Staff Report
to the
City of Sturgeon Bay Plan Commission
November 13, 2014

Preliminary/Final PUD – Hotel on West Waterfront

ADDENDUM TO EXECUTIVE SUMMARY

Title: Planned Unit Development – Hotel on West Waterfront

Alternate Color Scheme for Hotel

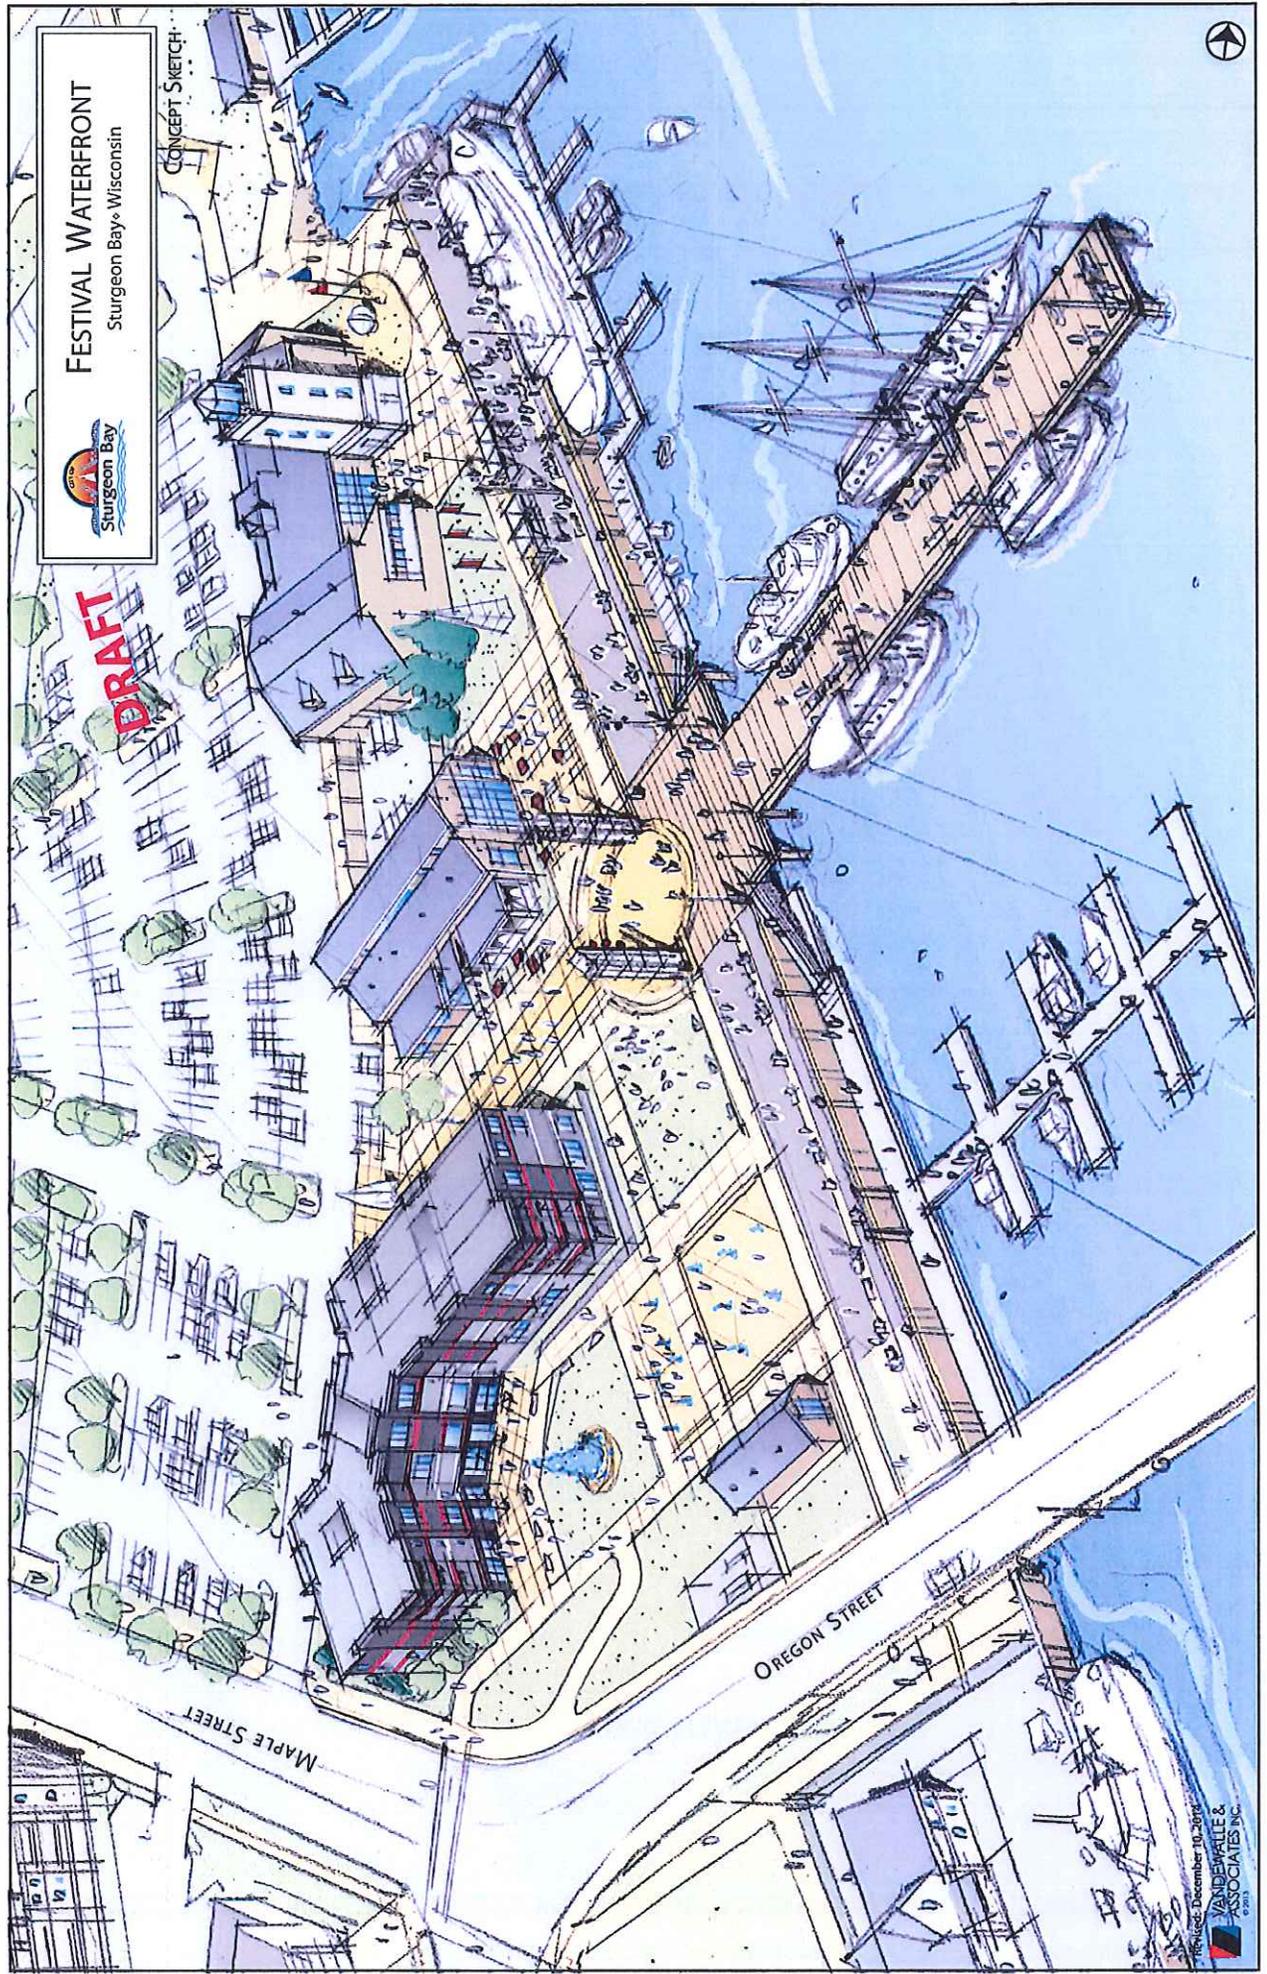
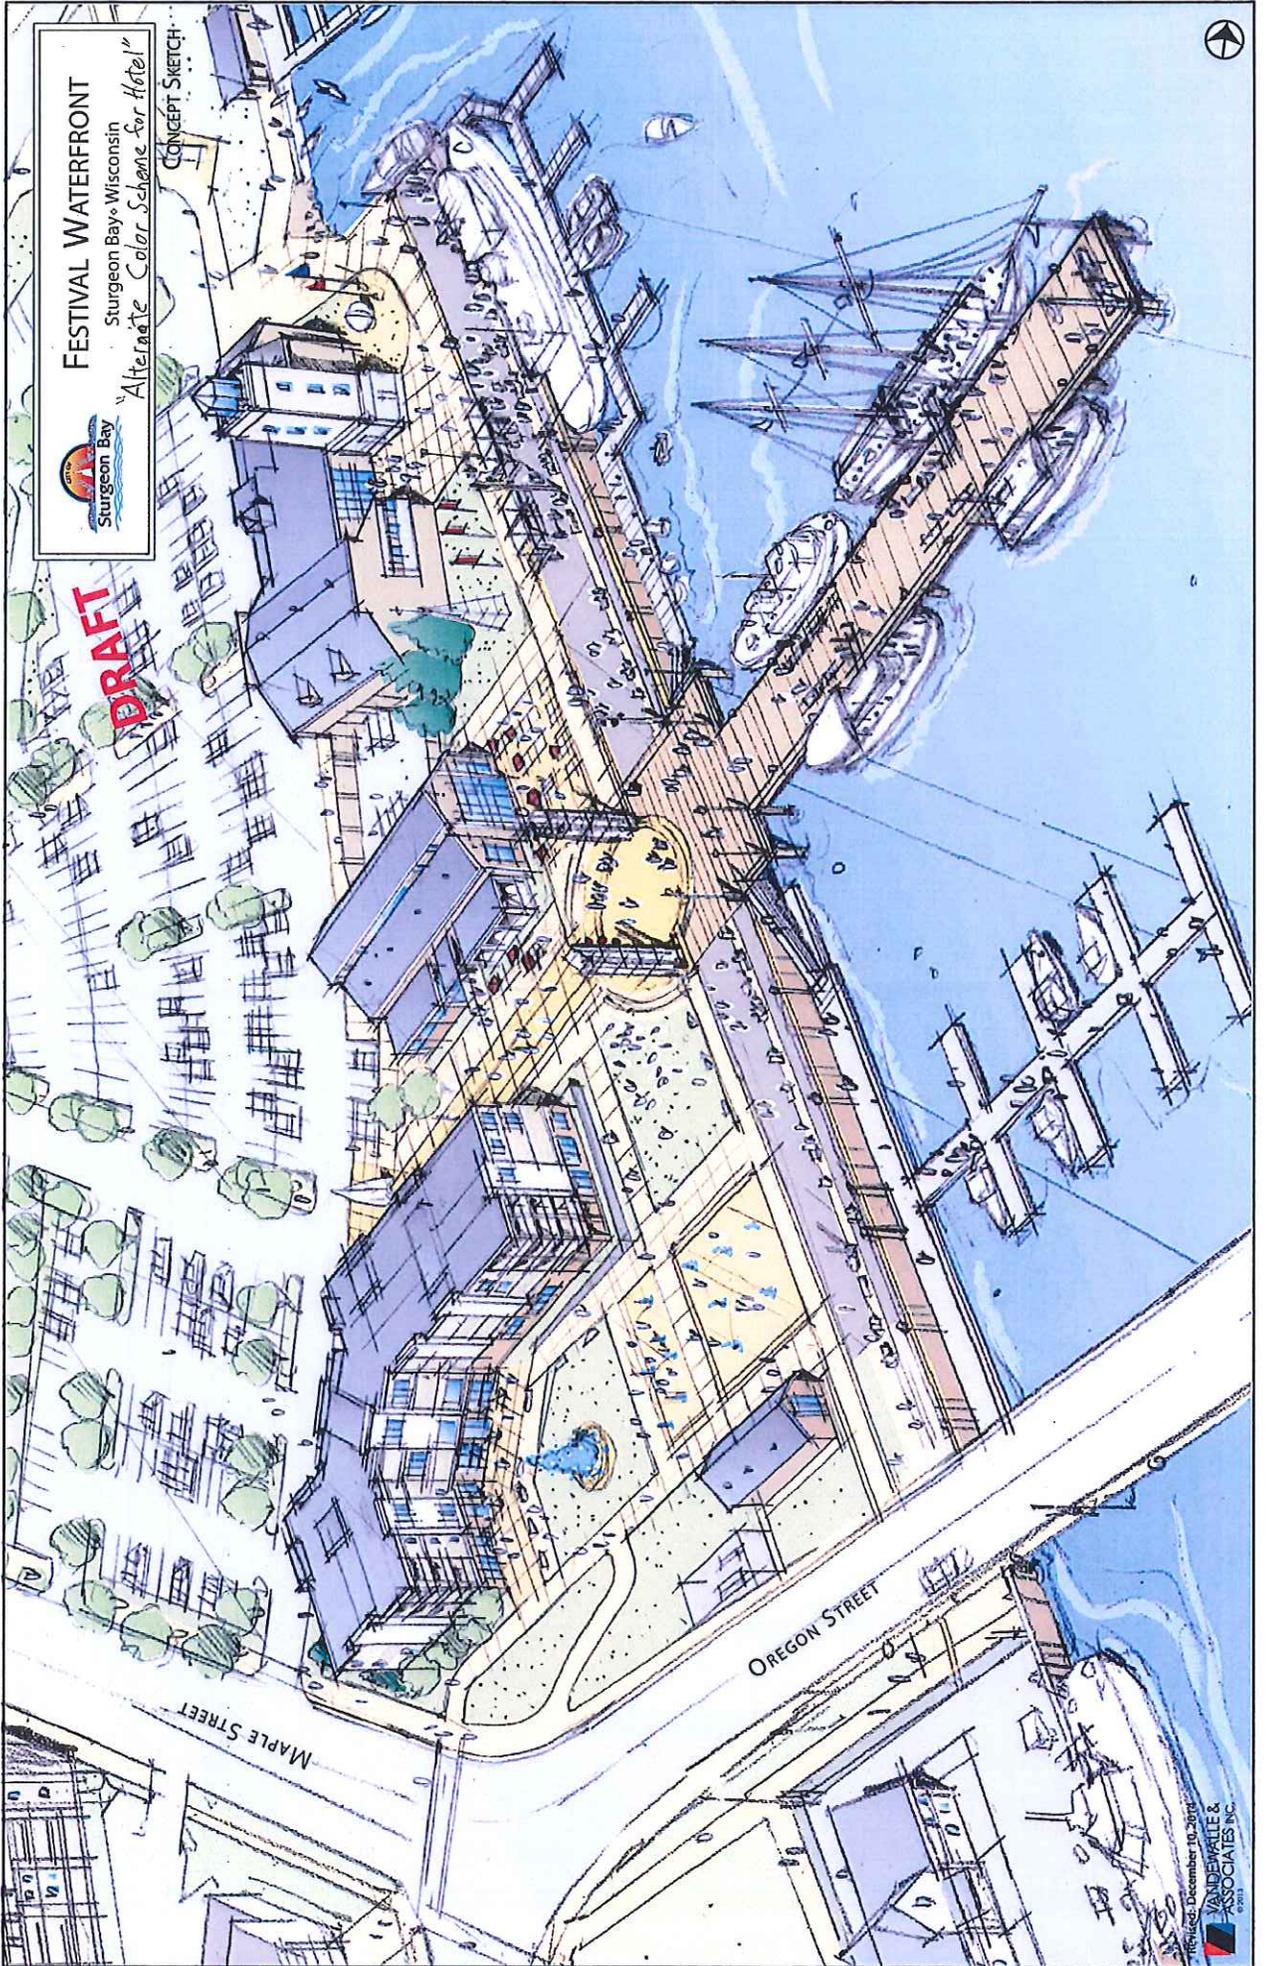
Building Design Changes: Many at the public hearing felt the building design was not good enough. Based upon input from Vandewalle & Associates and from staff, the developer made some revisions. These are in addition to the revisions described during the presentation prior to the hearing. The revised building elevations are included in the packet. The various changes are listed in the correspondence from Henry Isaksen, the developer's architect.

Overall Waterfront Design: Vandewalle & Associates was also asked to update the bird's eye perspective of the West Waterfront based upon the hotel and brewpub proposal. It seems that many of the speakers at the public hearing believed the proposed redevelopment project would eliminate public access to the waterfront. The actual redevelopment plan always envisioned enhanced public space along the water. The bird's eye view does a better job of showing how the hotel fits in with the public space. Please note that the Vandewalle drawing shows the hotel at four stories high. This is consistent with previous Vandewalle drawings for a future hotel and the consultant still believes a four story building is better.

1. Added more variation in the parapet heights
2. Combined the grey color palette with red accents
3. Changed the glass railings to cable
4. Added faux balconies on the northernmost end units
5. Changed the car cover to a flat roof, creating an exterior patio outside the second floor meeting room
6. Added additional 'bumpouts' and glass on the angled walls above the entry
7. Added a rooftop observation area adjacent to the north stairwell.
